OREM CITY
2025 Public Safety Remodel Project

ADDENDUM #2

March 5, 2025

A3.2

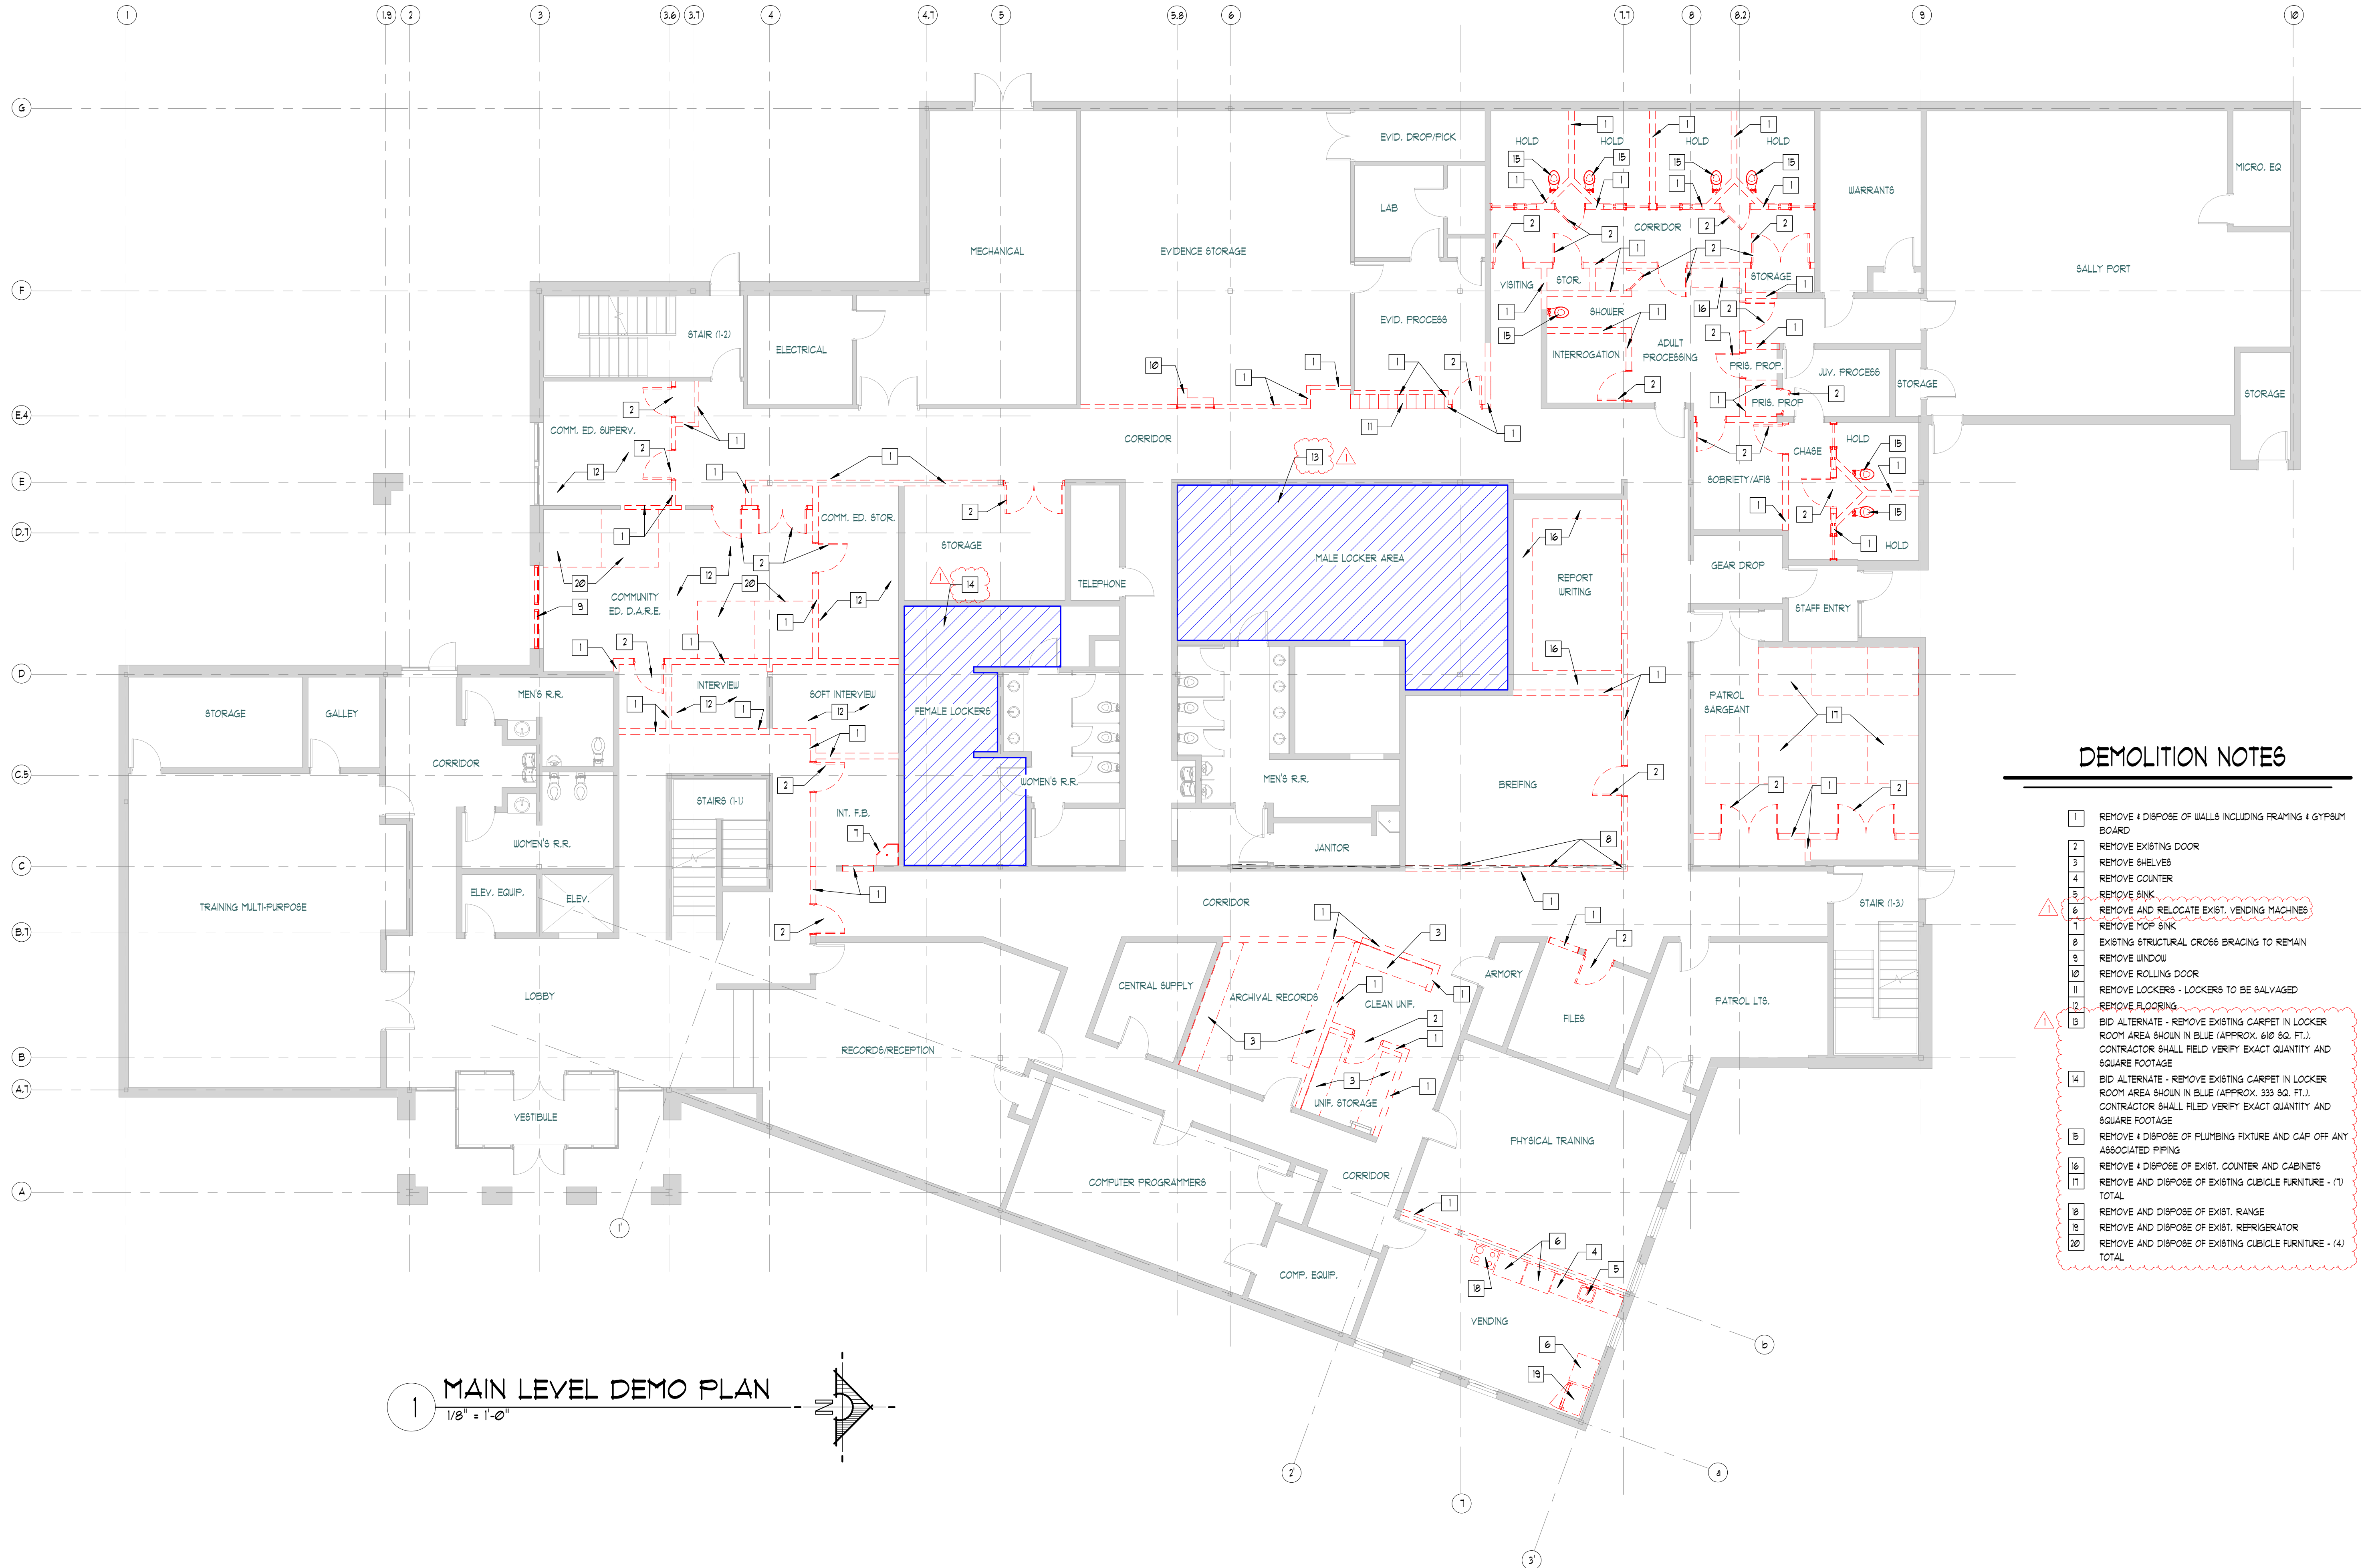
- **Question:** I'm reviewing the plans and specifications but haven't been able to locate the specific requirements for the polished concrete. Could you please provide me with the desired level of aggregate exposure and gloss level they wish to achieve?
 - **Answer:** *Concrete shall be polished to a level #2 finish with a clear finish. See sheet A3.2.*

| BASE | | | | | |
|----------|---------------------------------|------------------------|--|----------------|---|
| CONC | POLISHED CONCRETE | N/A | COLOR: CLEAR | N/A | POLISH EXIST. CONCRETE TO A LEVEL #2 FINISH |

ED1.1

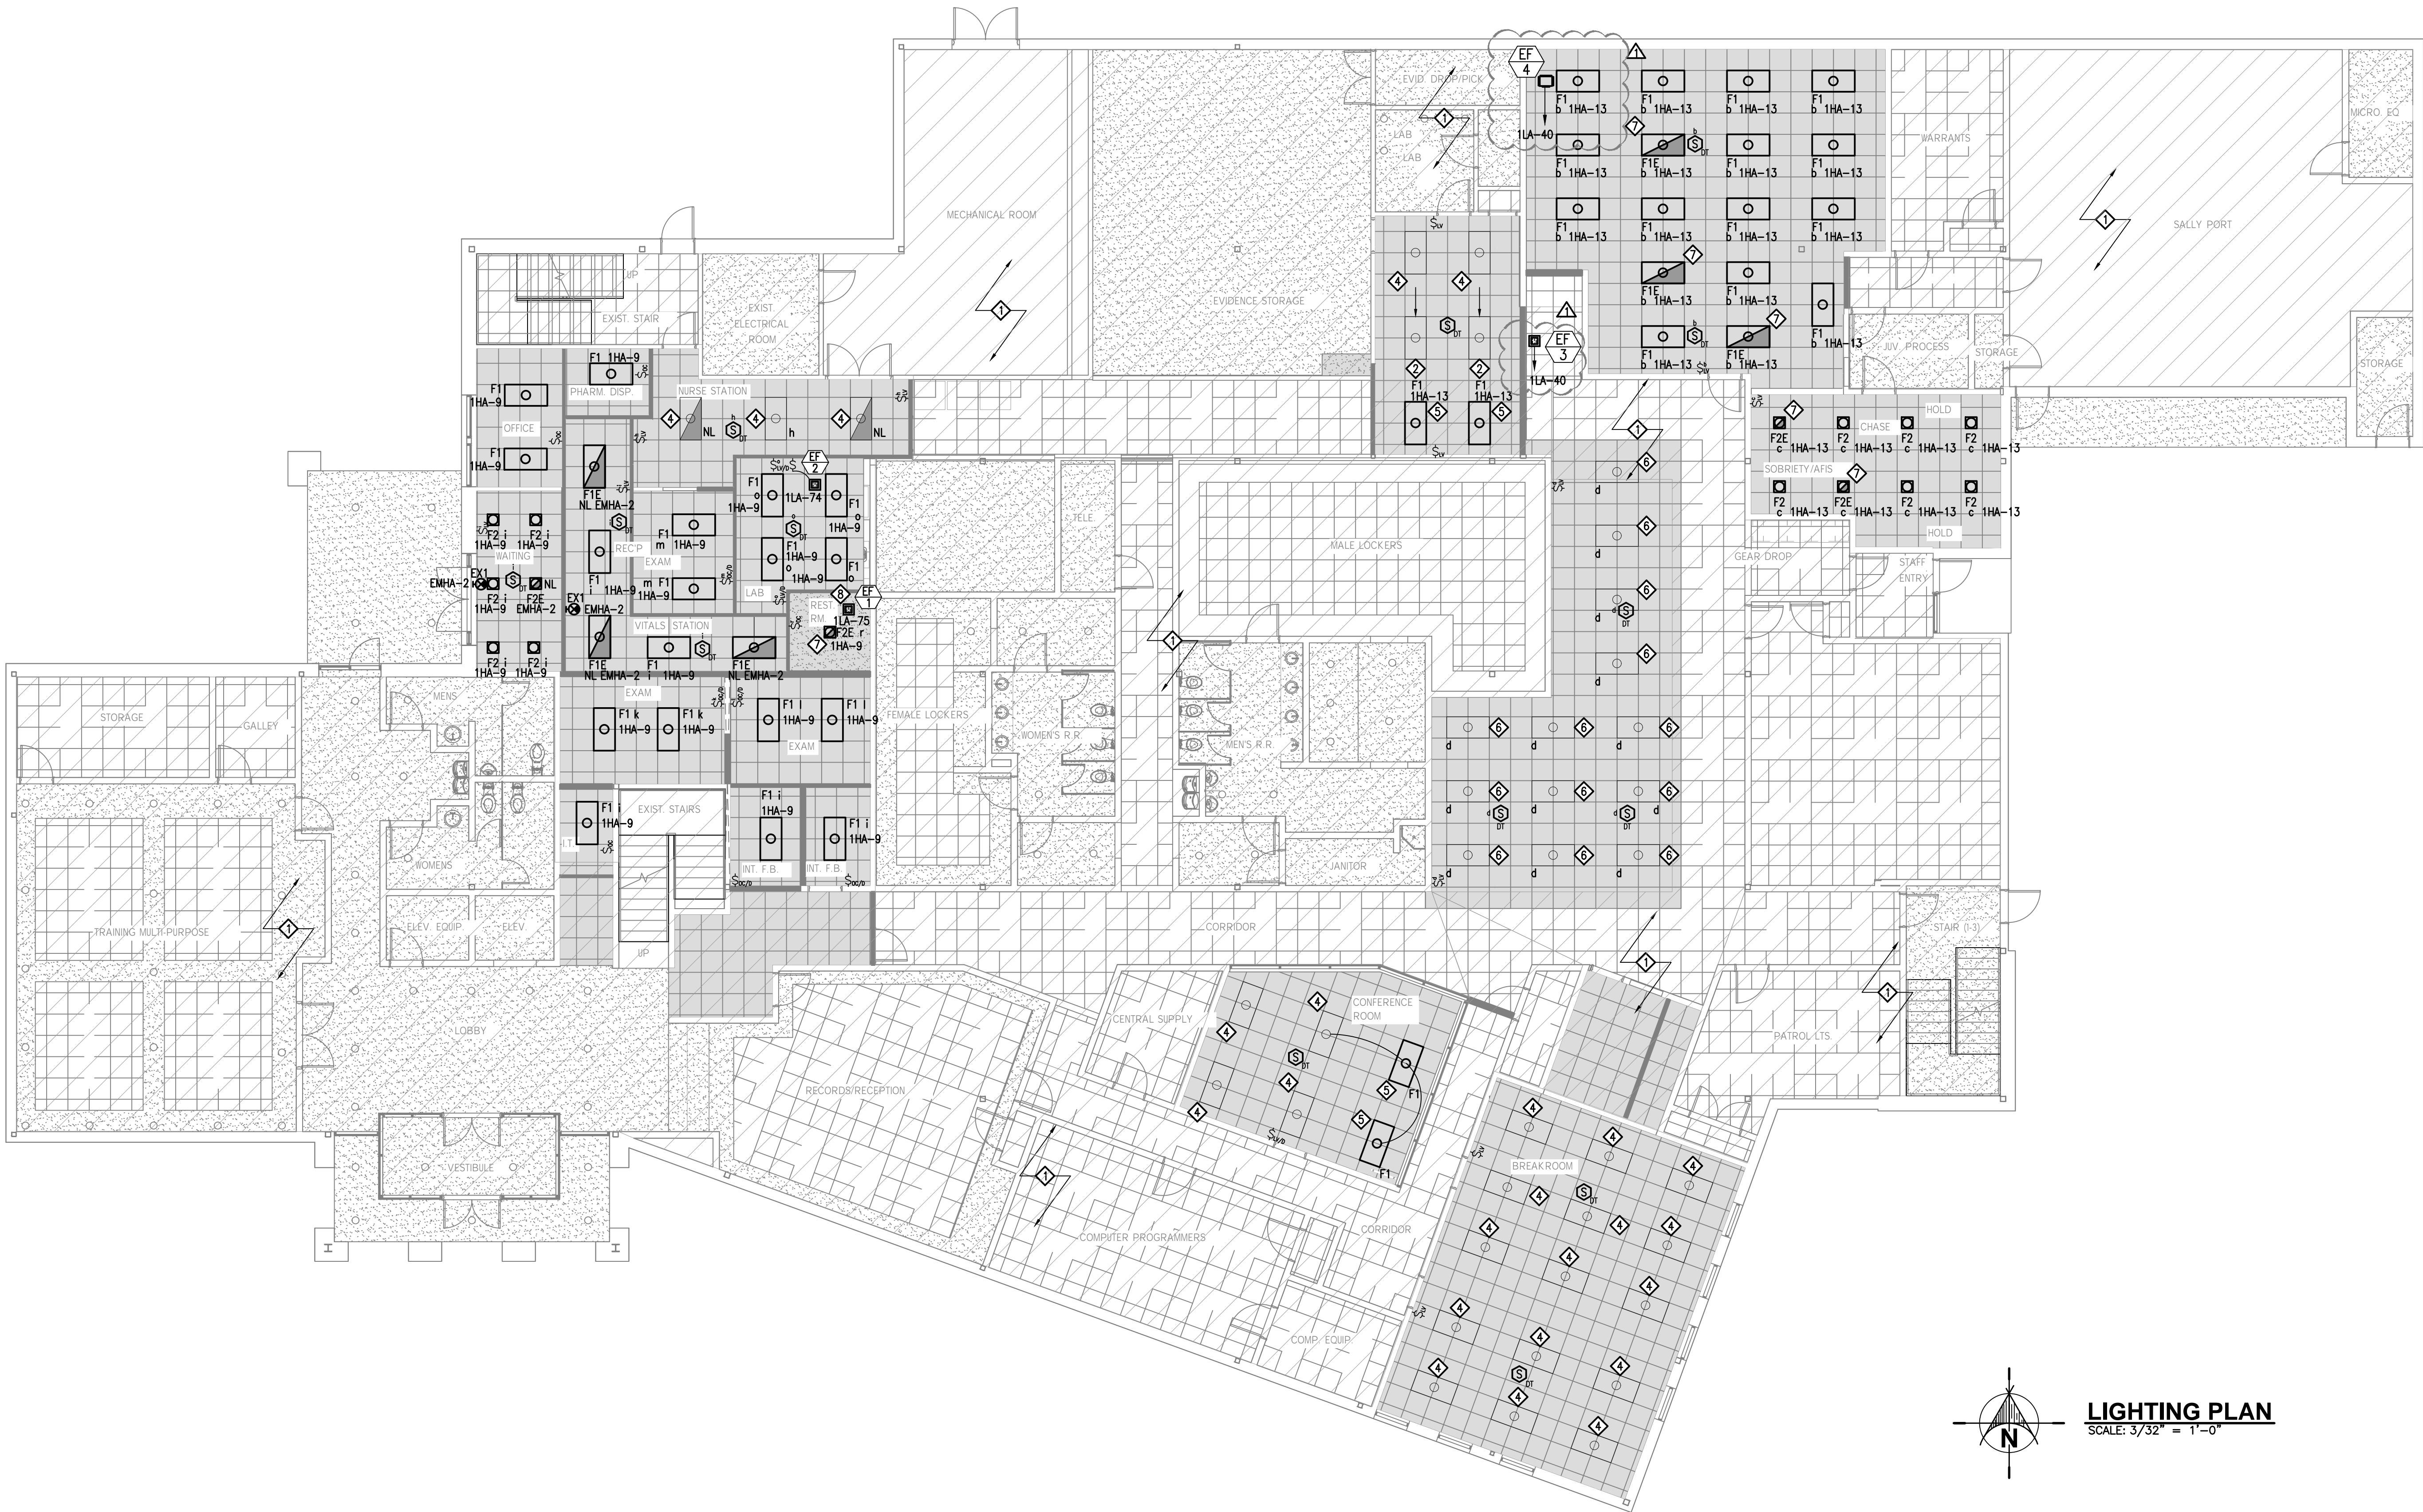
- **Question:** There is a duplex receptacle and data outlet in the Fitness Room called out on ED1.1 to be demo'd but on E1.1 it is called out to remain. These devices are on the north side of the wall from the Gear Drop area. Are these devices existing to remain? Receptacle and data to remain.
 - **Answer:** *Receptacle and data to remain. See updated sheet ED1.1.*
